Justification for Class III Permit Modification March 2005 SWMU 167 Operable Unit 1303 Building 940 Drain Systems at Technical Area II

**Justification for Class III Permit Modification
March 2005**

**SWMU 167
Operable Unit 1303
Building 940 Drain Systems at Technical Area II**

Comment Response October 1996

Figure 2. Map Showing ER Site 167 Building 940 Septic System

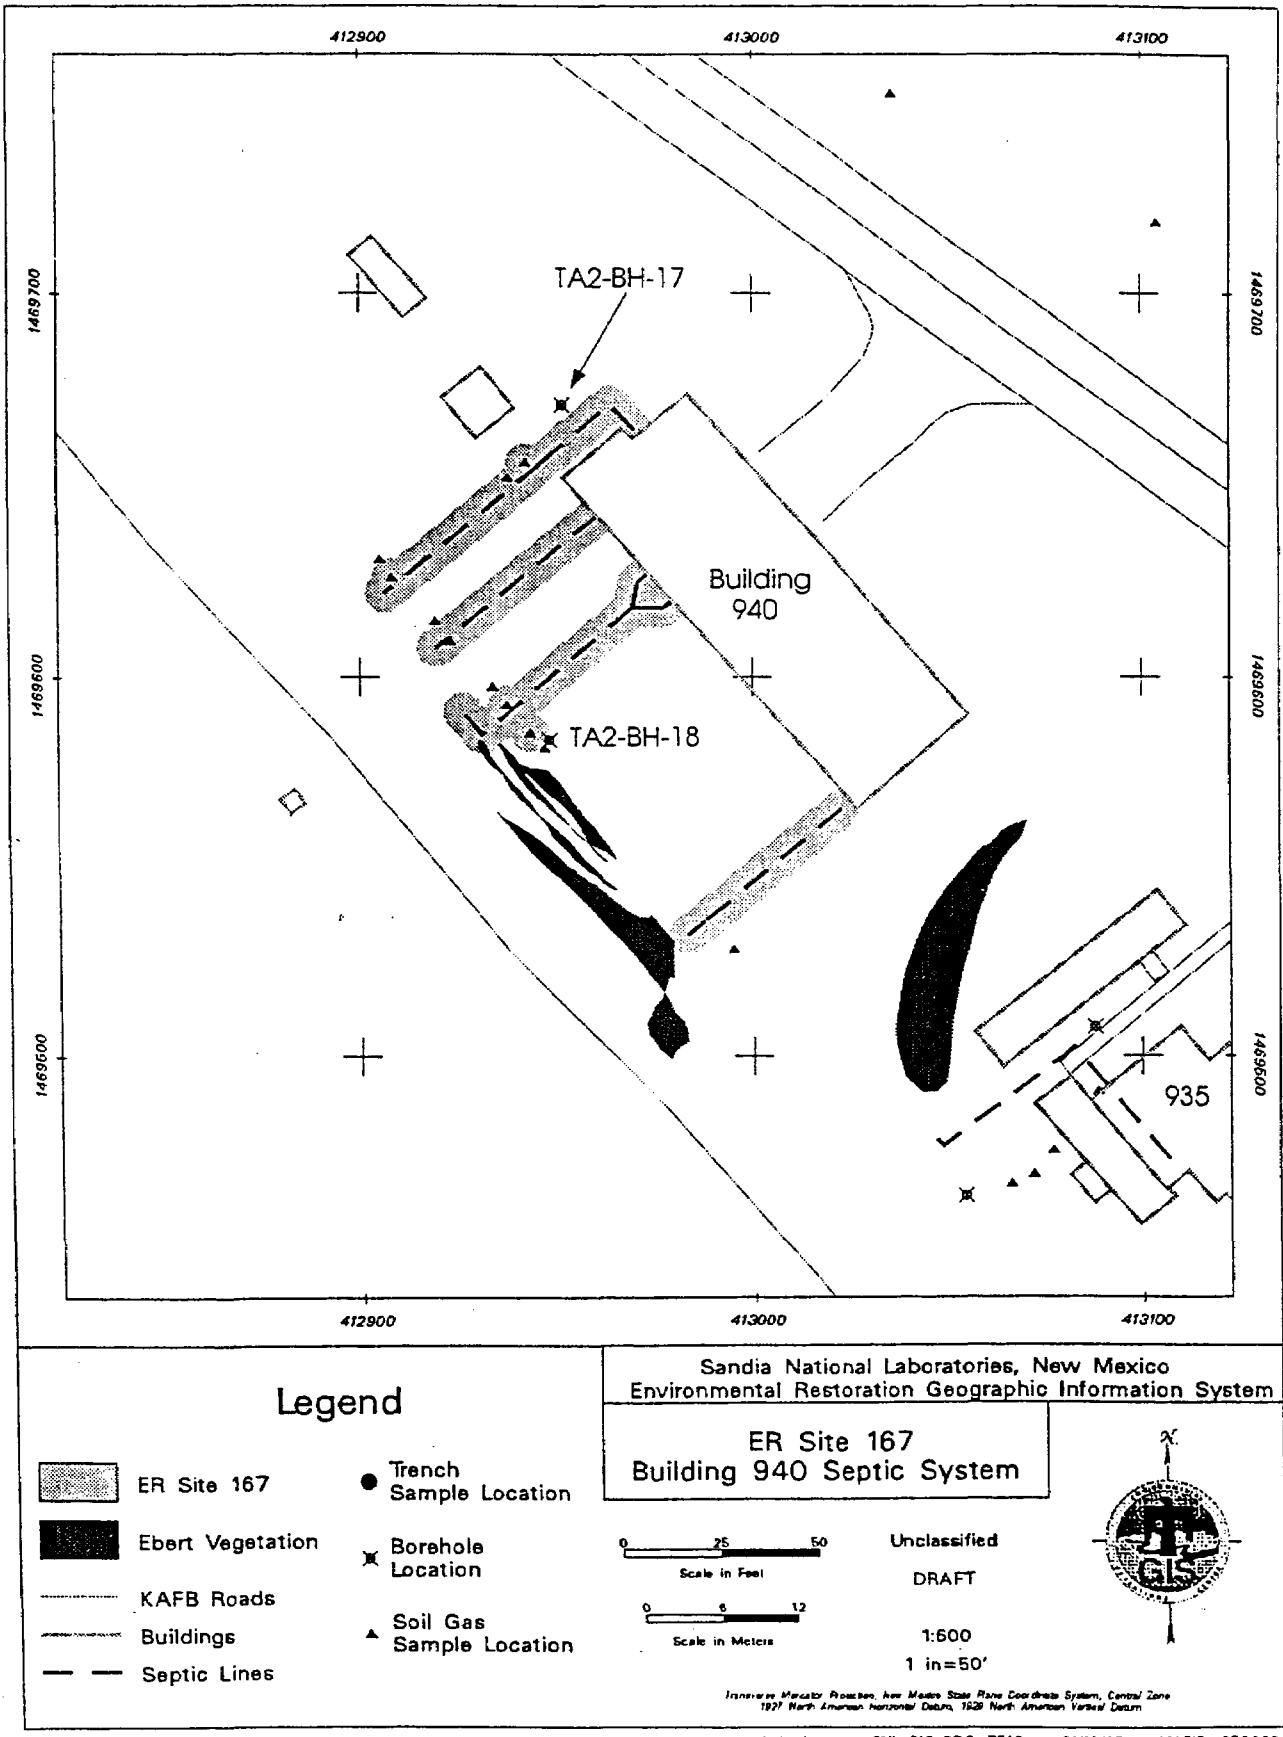
- c. **Please provide a more detailed map of Figure 2. In addition, please provide a more detailed schematic or map of the sanitary system which clearly identifies all components of the system.**

Response: The existing site maps have been revised to reflect the best-known information on all the TA-II septic and drain system sites. The changes are based on SNL/NM Facilities Engineering drawings and Global Positioning System (GPS) mapping of visible system components. To improve the accuracy of the site maps, an excavator and GPS surveying will be used to locate system components below grade, confirm drainfield dimensions, and pinpoint effluent release locations. Planning for this work is in progress. Accurate site maps will be available in May 2000. Any further sampling at TA-II ER septic and drain system sites will be discussed with NMED HRMB staff when the maps are finalized. Note that this comment also addresses ER Sites 135 and 165, which were not incorporated in the 2nd Round of the NFA proposals. After discussions with NMED HRMB, the HE rinse-water drain from Site 48 will be investigated at the same time as co-located ER Sites 227 and 229, which are managed by Tijeras Arroyo OU 1309.
